Removal And Disposal of Soils
Contaminated With PCBs
Along Highway Shoulders
In North Carolina

ADMINISTRATIVE ACTION
FINAL
ENVIRONMENTAL IMPACT STATEMENT
STATE OF NORTH CAROLINA

FINAL ENVIRONMENTAL IMPACT STATEMENT

CONCEPTUAL PLAN
CROSS-SECTION
DETAIL

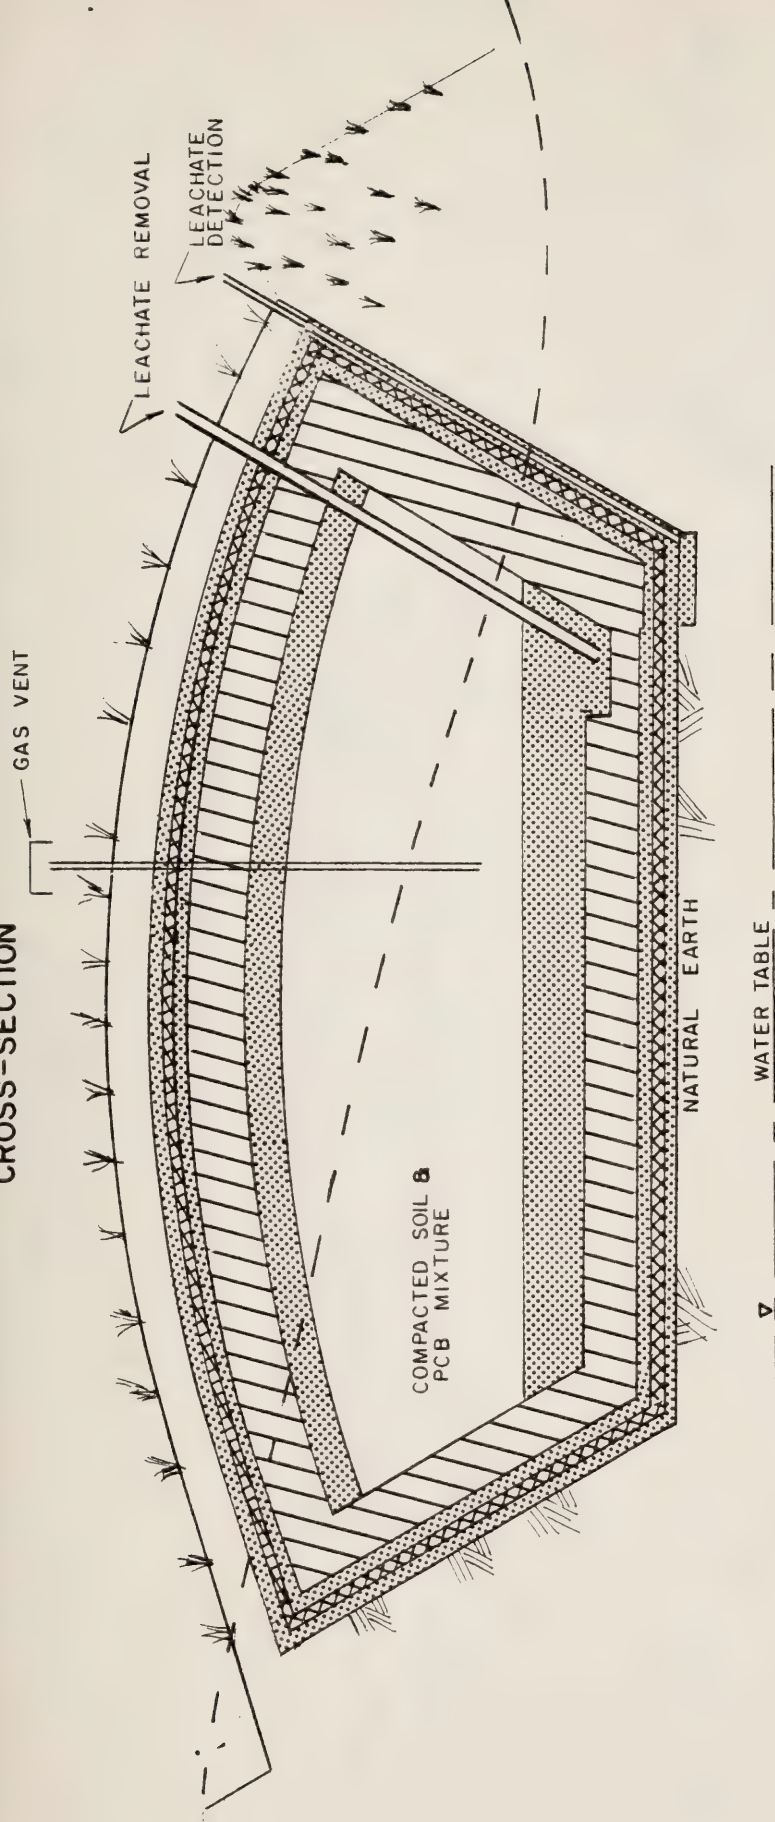
The plan allows numerous opportunities for human errors in construction: installing plastic liners and pipes, compacting the clay liner, driving trucks on top of buried pipes and close to plastic side liners, and close tolerance surface grading.

Response: The proposed conceptual plan for the PCB landfill has been revised in the final EIS, see page 11. The revised plan provides greater protection to the artificial liner and leachate collection system. As stated in response to question 1 a qualified consultant will be contracted to design, prepare construction plans and specifications and to see that the PCB landfill is built in accordance with those plans and specifications.

FIGURE 5

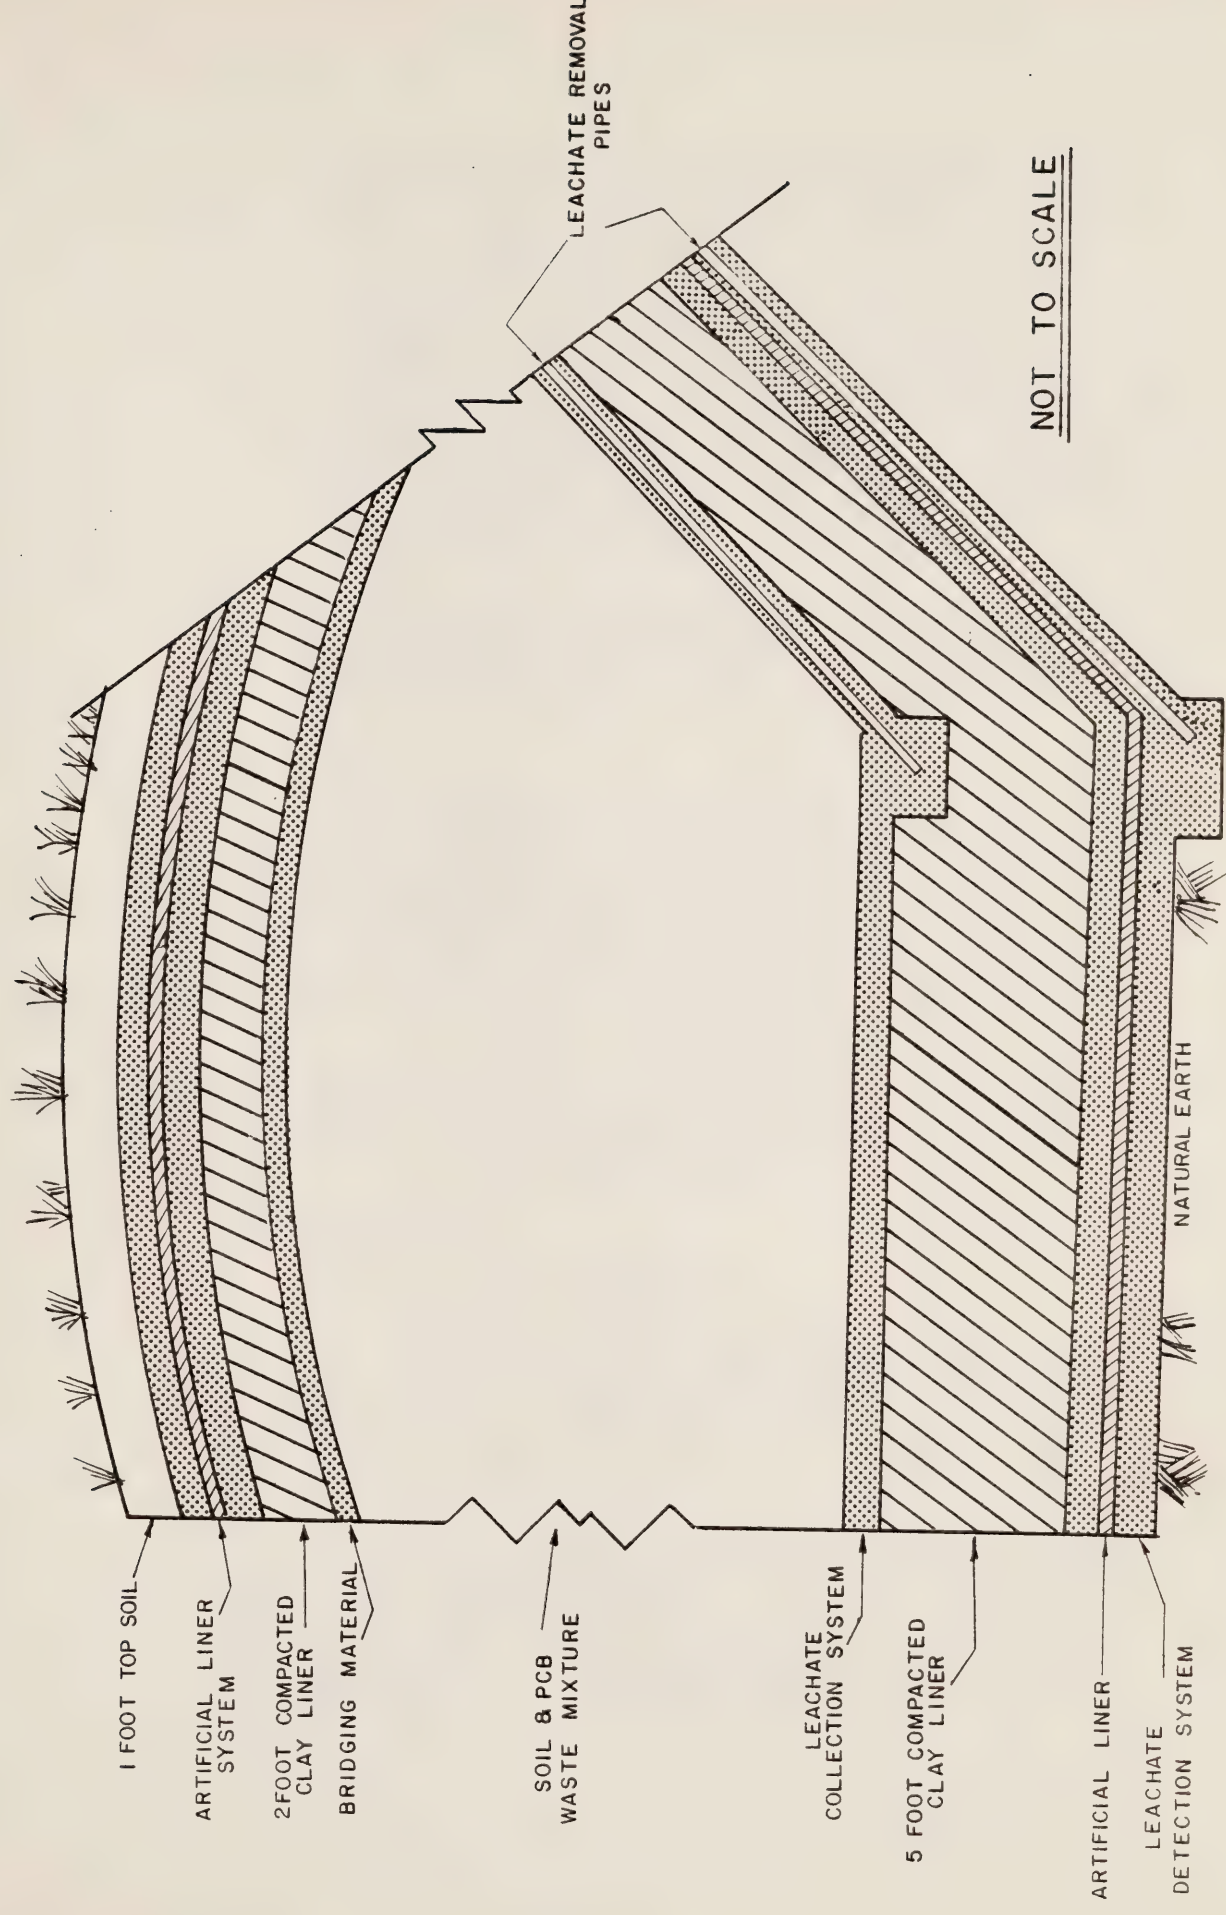
According to Figure 5, Section I. D., the landfill will not have a contiguous clay liner; the design fails to provide a uniform container of equal specifications for the bottom, sides and top. The DEIS provides no information to show that laterally moving groundwater or that animals will not be a problem. In addition, there is no information about the long term integrity of the artificial liner.

Response: The proposed conceptual design of the PCB waste landfill has been revised to reflect the above comment, see page 11.
